SUBJECT: Provides info on PWR feedwater lines in response to V Stello
 790525 request.

June 21, 1979
AEP:NRC:00215

Donald C. Cook Nuclear Plant Unit Nos. 1 and 2
Docket Nos. 50-315 and 50-316
License Nos. DPR-58 and DPR-74

INFORMATION REQUESTED ON PWR FEEDWATER LINESDESIGNREQUEST/QUESTION NO. 1

FULL SCALE SECTION OF EXISTING
WELD BETWEEN 16" SCH. 80 L.R. ELBOW IN
 AEP FEEDWATER LINE AND 16" SCH 60 WELD
 CONNECTION OF (W) STEAM GENERATOR

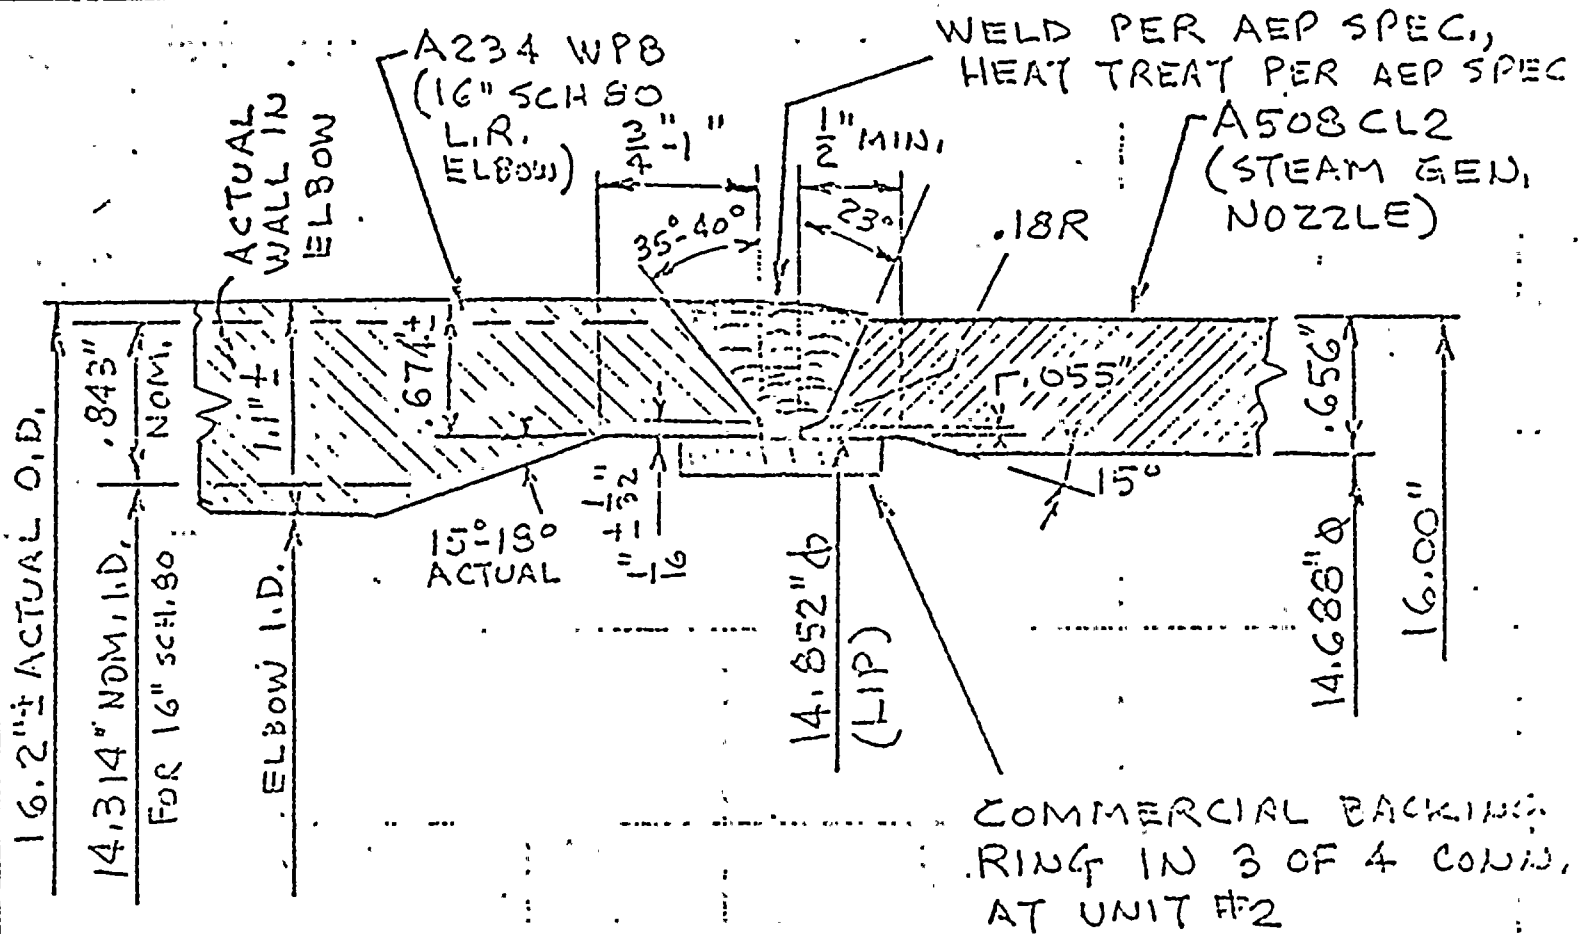
Provide the details of the welding process(es) used to make the nozzle-to-pipe, pipe to sparger and piping welds. Include details of welding such as preheat, joint configuration (include with or without backing ring), and post weld treatment, if any.

We have replaced the feedwater line elbows that are attached to the Steam Generator nozzles. The original welds on Unit 1 were a shielded metal arc weld using E7018 electrodes and backing rings. A preheat of 500°F minimum and a post weld heat treatment of 1150°F minimum for 1 hour was used. On Unit 2 Steam Generator Nos. 2, 3, and 4 nozzle to pipe elbow welds were made in the same manner. The nozzle to pipe elbow joint on Steam Generator No. 1 used an open root gas tungsten arc weld utilizing carbon steel filler metal. On Unit 2 the preheat was the same as Unit 1 and the post weld heat treatment was maintained between 1150 and 1200°F for one hour minimum. The geometry of the end preparation for both the nozzle and the elbow is shown in Figure 1.

$t_{min.}$ PER ANSI B31.1 = .563" FOR A234 WPB STL.

$t_{min.}$ PER ANSI B31.1 = .425" FOR A508CL2 STL.

$t_{weld} = .674" \pm$
